| Revisions |          |                               |       |
|-----------|----------|-------------------------------|-------|
| P03       | 09.03.17 | PLANNING AMENDMENT SUBMISSION | KI LP |

**1 ELEVATION**  
 EAST GA ELEVATION  
 1 : 500

Client  
 RFU  
 Project  
**TWICKENHAM STADIUM  
 EAST STAND EXTENSION**  
 Drawing title  
**GA ELEVATION 1**

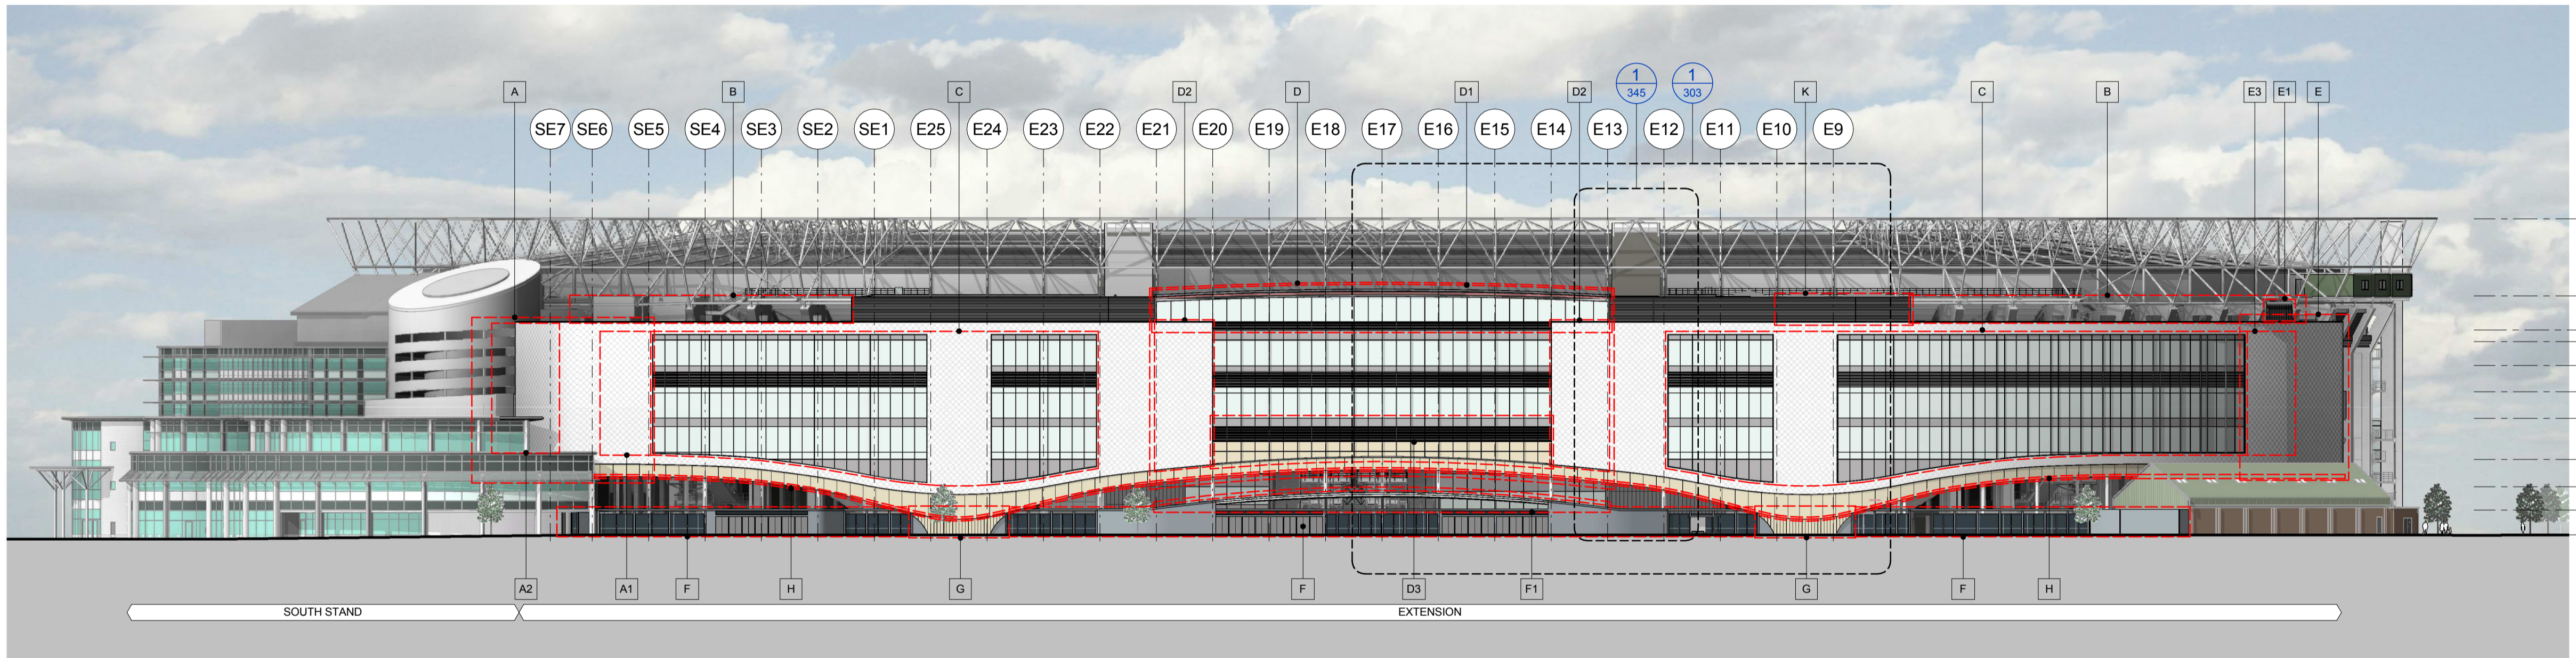
- A GENERAL AMENDMENTS TO THE SOUTH END.
- A1 INCREASED SHINGLES CLADDING AREA AND CURTAIN WALL REDUCED ACCORDINGLY.
- A2 REDUCED MASSING AND REVISED INTERFACE WITH THE SOUTH STAND.

- B PPC LOUVRES LOCATED TO THE BOWL SIDE HAVE BEEN OMITTED.
- C CURTAIN WALL SETTING OUT REVISED GENERALLY. SILICONE JOINTS TO TRANSOMS AND MULLION REPLACED WITH CAPPED SYSTEM. LEVEL 04 PPC LOUVRES: SETTING OUT & HEIGHT REVISED. MONORAIL FOR ABSEILING REMOVED.

- D GENERAL AMENDMENTS TO THE CENTRAL ELEVATION CANOPY AT LEVEL 5A REVISED GENERALLY AND STANDING SEAM REPLACED WITH SINGLE PLY MEMBRANE. SUPPORT COLUMNS TO ROOF CANOPY REVISED. SQUARE FASCIA TO ROOF EDGE.

- D1 LEVEL 5A GLAZED SCREEN EXTENDED IN HEIGHT AND PPC LOUVRES INCLUDED AT LOW LEVEL.
- D2 INCREASED SHINGLES CLADDING AREA AND CURTAIN WALL AREA REDUCED ACCORDINGLY. FOUR VERTICAL FINIS REMOVED.

- D3 PORCELAIN PANELS WITH SLOTTED HOLES FOR VENTILATION REPLACED WITH PPC LOUVRES. EXPRESSED HORIZONTAL PATTERN TO PORCELAIN PANELS OMITTED.
- E GENERAL AMENDMENTS TO THE NORTH END PORCELAIN CLADDING REPLACED WITH PPC ALUMINIUM CLADDING.

- E1 GREEN WALL TO THE NORTH END EXTENDED AND PPC LOUVRES REMOVED.
- E2 INCREASED SHINGLES CLADDING AREA AND CURTAIN WALL REDUCED ACCORDINGLY.
- E3 FENCELINE, GATE AND PERIMETER COLUMNS SETTING OUT REVISED.

- F CANOPY TO TURNSTILES REVISED.
- F1 PORCELAIN PATTERN CHANGED FROM HORIZONTAL TO VERTICAL.
- G PORCELAIN PANELS TO THE SOFFIT OF THE ARCH REPLACED WITH PPC ALUMINIUM PANELS. PORCELAIN PANELS SETTING OUT REVISED.

- H ROOF TO LEVEL 5A (NORTH END) EXTENDED.
- K GLAZED SPANDREL PANELS REPLACED WITH METAL SPANDREL PANEL. PORCELAIN PANELS REPLACED WITH PPC ALUMINIUM CLADDING.

- L PPC LOUVRES INCLUDED FOR MECHANICAL VENTILATION.
